Submission of Further Information (FI)

**Temporary Animal Boarding Establishment with Ancillary Facilities and associated
Filling of Land for a period of 5 years in "Agriculture" Zone,
Lot Nos. 1493 (Part) and 1500 (Part) in D. D. 107 and Adjoining
Government Land, Yuen Long, New Territories
(Application No. A/YL-KTN/1177)**

Further Information for Planning Application No. A/YL-KTN/1177**Response-to-Comments****Comments from Drainage Services Department**

Plan 6.2c
(P 23044)

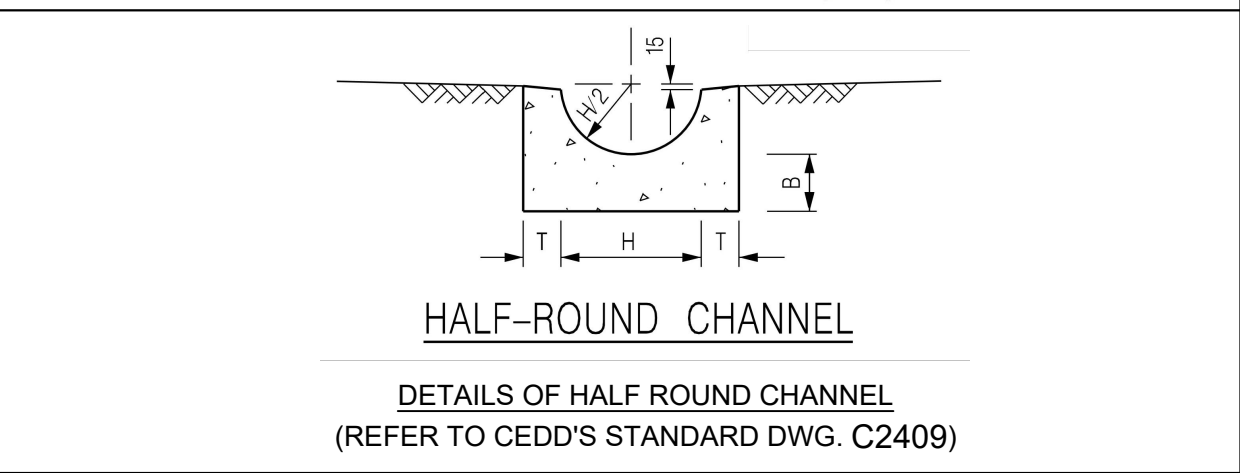
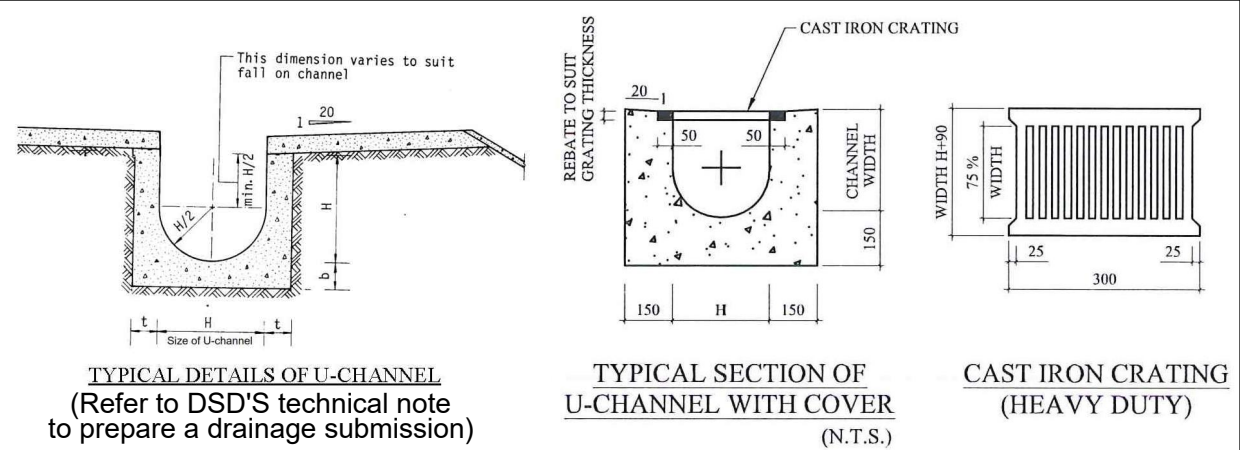
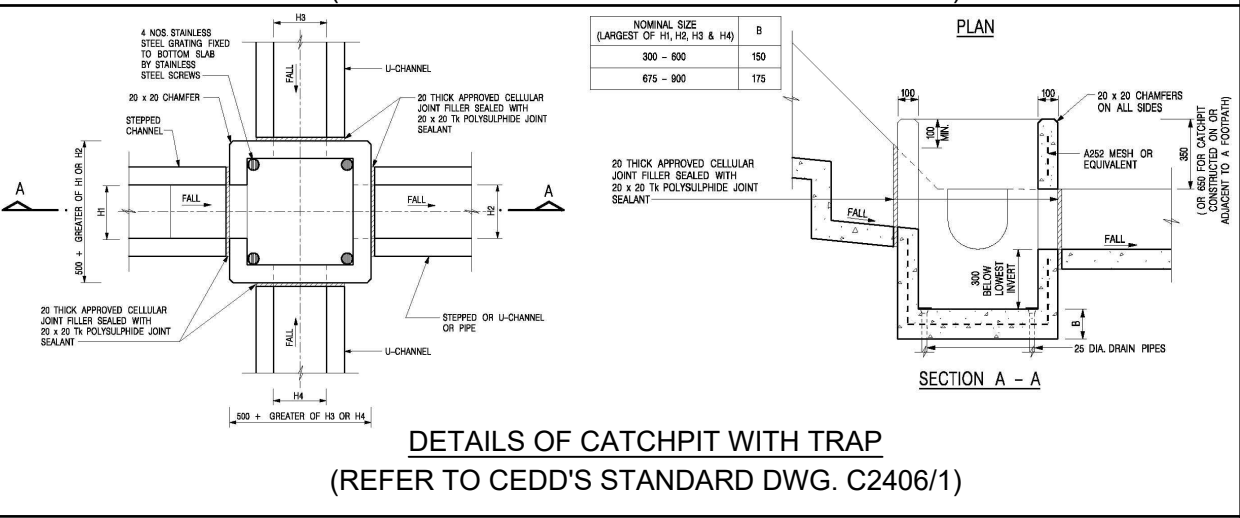
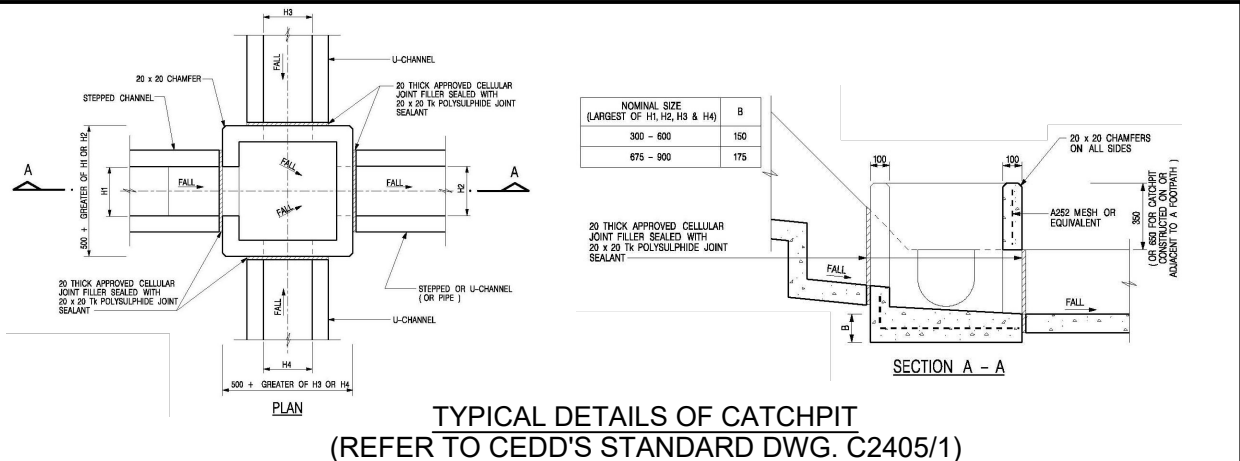
I.	Comments	Responses
1.	Plan 6.1b: The applicant should review alignment of the proposed drainage facilities connecting catchpits CP2 and CP4.	The alignment of the drainage facilities connecting catchpits CP2 and CP4 is reviewed. Please refer to Plan 6.1b.

12.	Consideration should be given to provide grating for the surface channels.	Grating is provided for the surface channels. Please refer to Plan 6.1b.
